## **Exhibit 2: Gershwin Theater**

### **Exhibit 2B: Architectural Modifications**

**Exh. 2B Architectural Modifications to Gershwin Theater**

2. **GERSHWIN THEATER**  
**4TH FLOOR NORTH - WOMEN MULTI-USER TOILET ROOM PLAN**

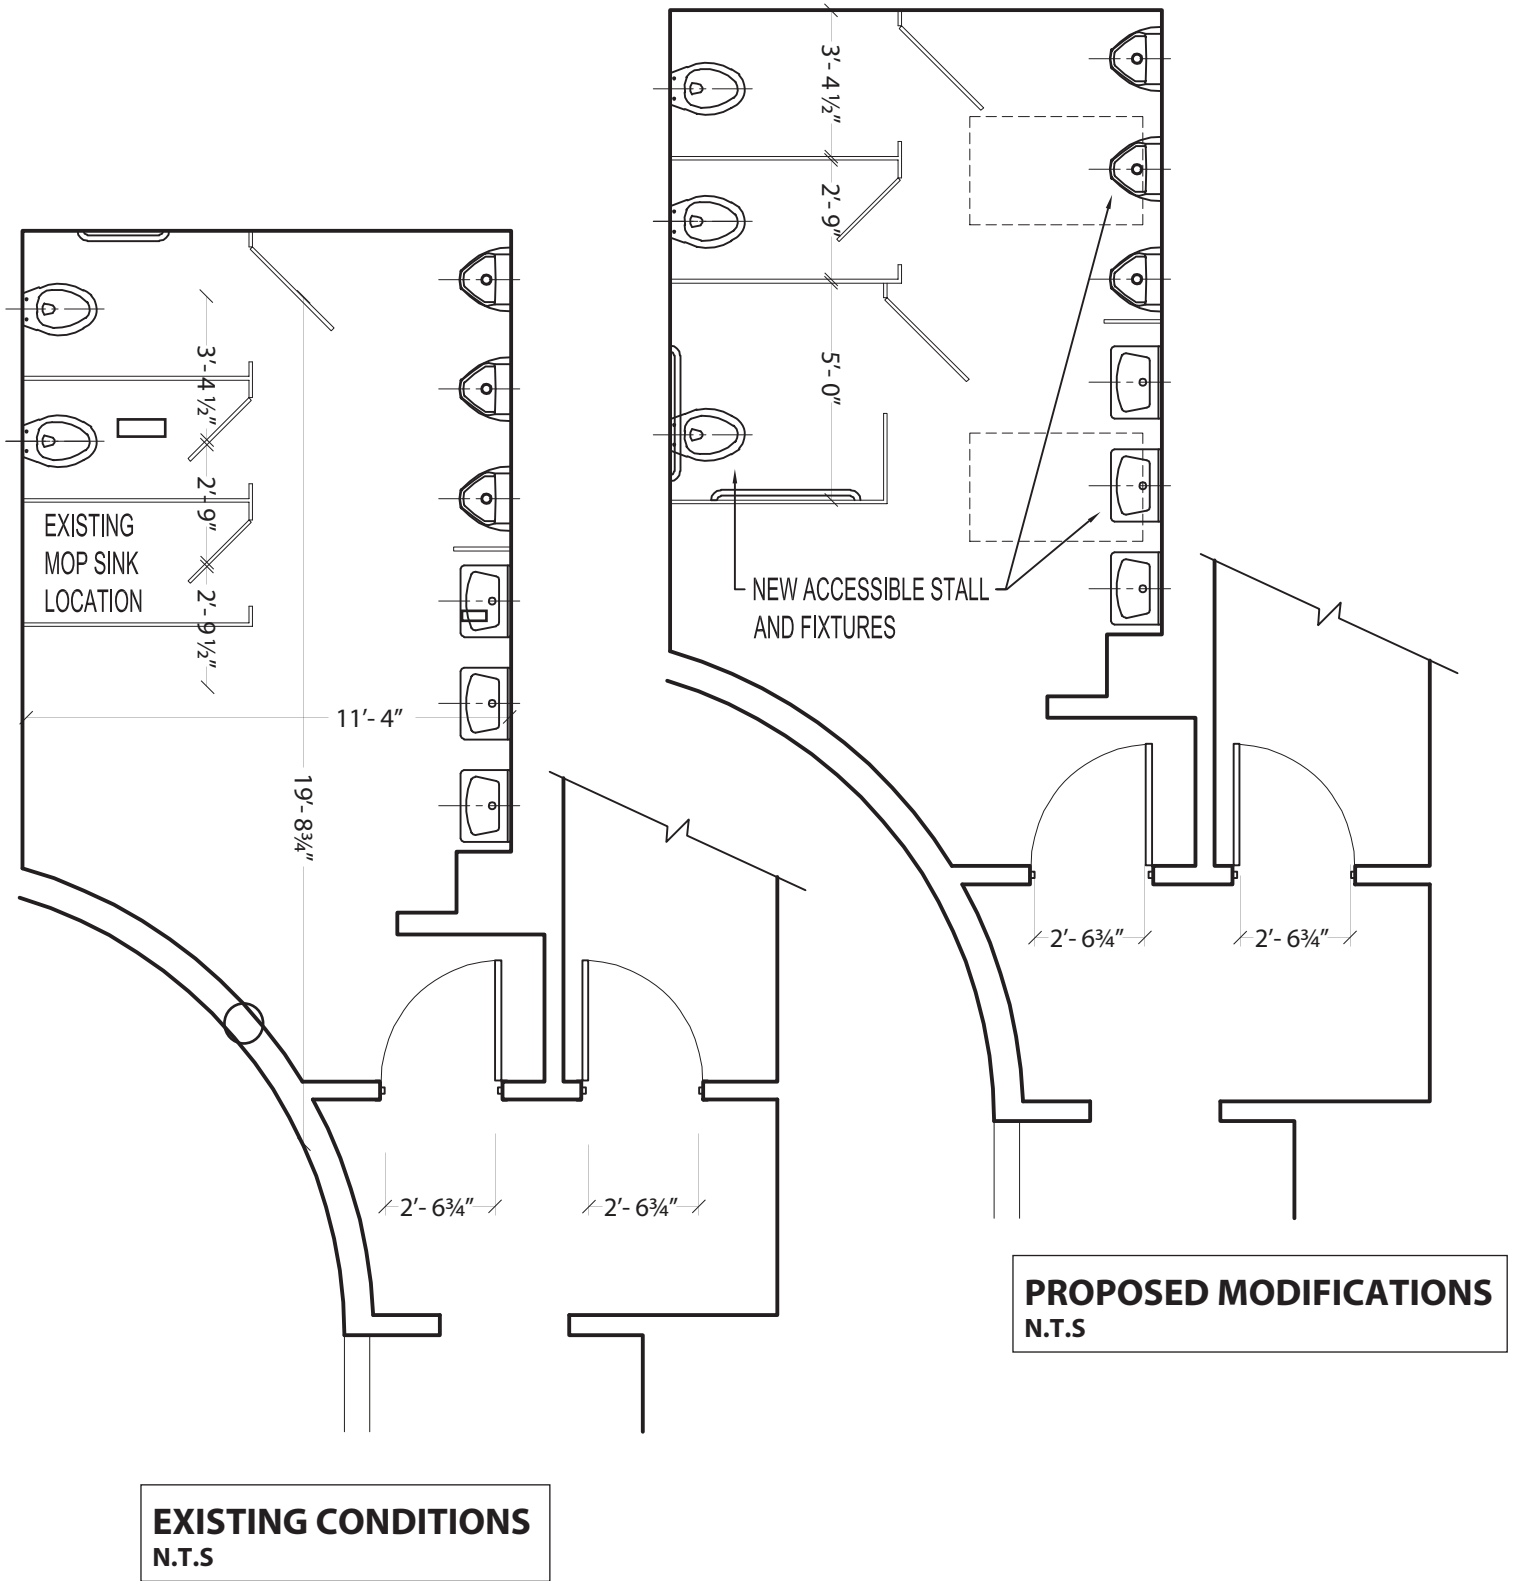
8	Fourth Level (Women's Multi-user Toilet Room, North)	The main entry door is 34" wide and provides 31" clear width.	Remove existing door, widen opening, and install new door that provides the minimum required clear width. Coordinate with maneuvering clearance requirements.	4.1.3(7)(c) 4.13.5 Fig. 24	<b>Defendant will provide compliant door.</b>
9	Fourth Level (Women's Multi-user Toilet Room, North)	Door hardware requires tight grasping, pinching, and/or twisting of the wrist to operate.	Remove existing operating hardware and install compliant hardware.	4.1.3(7)(c) 4.13.9	<b>Defendant will provide compliant hardware.</b>
10	Fourth Level (Women's Multi-user Toilet Room, North)	Door hardware requires tight grasping, pinching, and/or twisting of the wrist to operate.	Remove existing operating hardware and install compliant hardware.	4.1.3(7)(c) 4.13.9	<b>Defendant will provide a compliant women's standard accessible bathroom on fourth level North, adjacent to lounge entrance to women's room on fourth level North.</b>

<b>Line #</b>	<b>Location Description</b>	<b>Existing Condition</b>	<b>Barrier Description</b>	<b>1991 Standards Reference</b>	<b>Architectural Modification</b>
11	Fourth Level (Women's Multi-user Toilet Room, North)	The pull side maneuvering clearance width is 6.5".	Alter existing walls and/or relocate existing door and frame to obtain required maneuvering clearances.	4.13.6 Fig. 25( a-f)	Defendant will provide a compliant women's standard accessible bathroom on fourth level North, adjacent to lounge entrance to women's room on fourth level North.
12	Fourth Level (Women's Multi-user Toilet Room, North)	The wall sconce protrudes into the circulation path 9.25" at 62.5" AFF.	Raise wall sconce to greater than 80" AFF without altering fixture.	4.4.1 Fig.8(a-e)	Defendant will provide a compliant women's standard accessible bathroom on fourth level North, adjacent to lounge entrance to women's room on fourth level North.

13	Fourth Level (Women's Multi-user Toilet Room, North)	Knee space at the counter mounted lavatories is 26" AFF at the front edge.	Remove the existing lavatory and counter. Install a new compliant counter and reinstall the existing lavatory. Repair/refinish wall as needed.	4.1.3(11) 4.22.6 4.19.2 Fig. 31	Defendant will provide a compliant women's standard accessible bathroom on fourth level North, adjacent to lounge entrance to women's room on fourth level North.
14	Fourth Level (Women's Multi-user Toilet Room, North)	This non-fire rated door requires 11 pounds of force to open.	Adjust the existing closer to provide compliant speed and force. (May inhibit proper latching. If so, replace existing closer with compliant model which allows door to operate as intended).	4.1.3(7)(c) 4.13.10	Defendant will provide a compliant women's standard accessible bathroom on fourth level North, adjacent to lounge entrance to women's room on fourth level North.

15	Fourth Level (Women's Multi-user Toilet Room, North)	The soap dispenser is mounted at 54" AFF, 12" deep, side reach.	Relocate the existing soap dispenser within reach range. Repair/refinish wall as needed.	4.1.3(11) 4.22.7 4.27 4.2.5 4.2.6	Defendant will provide a compliant women's standard accessible bathroom on fourth level North, adjacent to lounge entrance to women's room on fourth level North.

<b>Line #</b>	<b>Location Description</b>	<b>Existing Condition</b>	<b>Barrier Description</b>	<b>1991 Standards Reference</b>	<b>Architectural Modification</b>
16	Fourth Level (Women's Multi-user Toilet Room, North)	The threshold at the door from the lounge to the toilet room has a 1/2" vertical rise and is unbeveled on the toilet room side of the threshold.	Remove the existing threshold and install a compliant threshold.	4.1.3(7)(c) 4.1.6(3)(d)(ii) 4.13.8 4.5.2 Fig.7(c,d)	<b>Defendant will provide a compliant women's standard accessible bathroom on fourth level North, adjacent to lounge entrance to women's' room on fourth level North.</b>
17	Fourth Level (Women's Multi-user Toilet Room, North)	The toilet paper dispenser is mounted 41.25" from the rear wall on the side opposite the side grab bar.	Relocate existing compliant toilet paper dispenser as required, ensuring 1 1/2" clearance below grab bar. Repair/refinish wall or partition as needed.	4.16.6 Fig. 29(b) Fig. 30(d)	<b>Defendant will provide a compliant women's standard accessible bathroom on fourth level North, adjacent to lounge entrance to women's room on fourth level North.</b>

18	Fourth Level (Women's Multi-user Toilet Room, North)	There are 3 stalls in this toilet room, the largest being 41" wide x 63" deep with an inswinging door.	Creation of a compliant standard accessible stall requires removal of existing fixture(s) (check plumbing code). Relocate partition(s) and fixture(s) as required.	4.1.3(11) 4.22	<b>Defendant will provide a compliant women's standard accessible bathroom on fourth level North, adjacent to lounge entrance to women's' room on fourth level North.</b>
19	Fourth Level (Women's Multi-user Toilet Room, North)	There is no raised lettering and Braille room identification sign provided at this gender specific multi-user toilet room.	Install compliant (includes raised lettering and Braille) room identification signage adjacent to strike side of door at 60" AFF to centerline. Coordinate with requirement for close approach without encountering protruding object or door swing.	4.1.3(16)(a) 4.30.1 4.30.4 4.30.5 4.30.6	<b>Defendant will provide compliant sign.</b>

20	Fourth Level (Women's Multi-user Toilet Room, North)	There is no rear grab bar.	Install new compliant rear grab bar. Provide backing in wall as necessary.	4.17.6 Fig. 29 Fig. 30	<b>Defendant will provide a compliant women's standard accessible bathroom on fourth level North, adjacent to lounge entrance to women's room on fourth level North.</b>

<b>Line #</b>	<b>Location Description</b>	<b>Existing Condition</b>	<b>Barrier Description</b>	<b>1991 Standards Reference</b>	<b>Architectural Modification</b>
21	Fourth Level (Women's Multi-user Toilet Room, North)	The water closet seat height is 19.25" AFF and it is mounted 19.75" to centerline from the side wall.	Floor-mounted water closet: replace existing water closet with compliant water closet with seat installed 17"-19" AFF and 18" centerline to side wall. Adapt flush control as needed.	4.16.3 Fig. 29(b) 4.16.2 4.17.3 Fig. 28 Fig.30	<b>Defendant will provide a compliant women's standard accessible bathroom on fourth level North, adjacent to lounge entrance to women's room on fourth level North.</b>
22	Fourth Level (Women's Multi-user Toilet Room, North)	The paper towel dispenser is mounted at 56.5" AFF.	Install new towel dispenser within reach range where required clear floor space is available. Existing noncompliant towel dispenser may remain.	4.1.3(11) 4.22.7 4.27.3	<b>Defendant will provide a compliant women's standard accessible bathroom on fourth level North, adjacent to lounge entrance to women's room on fourth level North.</b>
